Access Compliance Report

Public Rights-of-Way

(Pedestrian Signals)

Intersection ID: N/A	Main Street:	Cross Street: N/A	Location: N/A
ADA ID: D9C17EE66CEC	Signal Type: One Push Button-APS	Overall Compliance: No	Severity Score: BTN 1: N/A BTN 2: N/A No BTN: N/A
Codes/Mitigation Info/Possible Solution		Field Measurements/Component Compliance

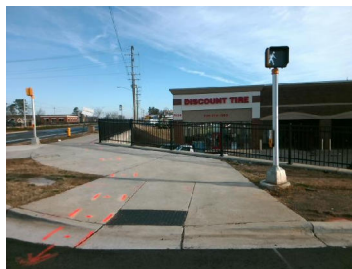
PROW/ADA: R404.2, R404.7.2, R209.1,
MUTCD 4e.10

N/A	B 1 FWD Approach Width (in)	N/A	N/A	B 2 FWD Approach Width (in)	N/A
N/A	B 1 FWD Approach Obstruction?	Yes	N/A	B 2 FWD Approach Obstruction?	N/A
N/A	B 1 FWD Approach Obstruction Dist (in)	3.0	N/A	B 2 FWD Approach ObstructionDist (in)	N/A
N/A	B 1 PARA Approach?	Yes	N/A	B 2 PARA Approach?	N/A
N/A	B 1 PARA Approach Constrained?	Yes	N/A	B 2 PARA Approach Constrained?	N/A
Yes	B 1 PARA Approach Reach (in)	8.0	N/A	B 2 PARA Approach Reach (in)	N/A
No	B 1 PARA Approach Width (in)	48.0	N/A	B 2 PARA Approach Width (in)	N/A
N/A	B 1 PARA Approach Obstruction?	Yes	N/A	B 2 PARA Approach Obstruction?	N/A
N/A	B 1 PARA Approach Obstruction Dist (in)	4.0	N/A	B 2 PARA Approach ObstructionDist (in)	N/A
Yes	B 1 Clear Floor Space Slope (%)	1.5	N/A	B 2 Clear Floor Space Slope (%)	N/A
No	B 1 Clear Floor Space XSlope (%)	2.8	N/A	B 2 Clear Floor Space XSlope (%)	N/A
N/A	B 1 PAR Slope (%)	N/A	N/A	B 2 PAR Slope (%)	N/A
Yes	B 1 Height (in)	40.0	N/A	B 2 Height (in)	N/A

Possible Solutions: Remove & Replace
Replace APS Button With New APS Button.
Remove and Replace Clear Space.
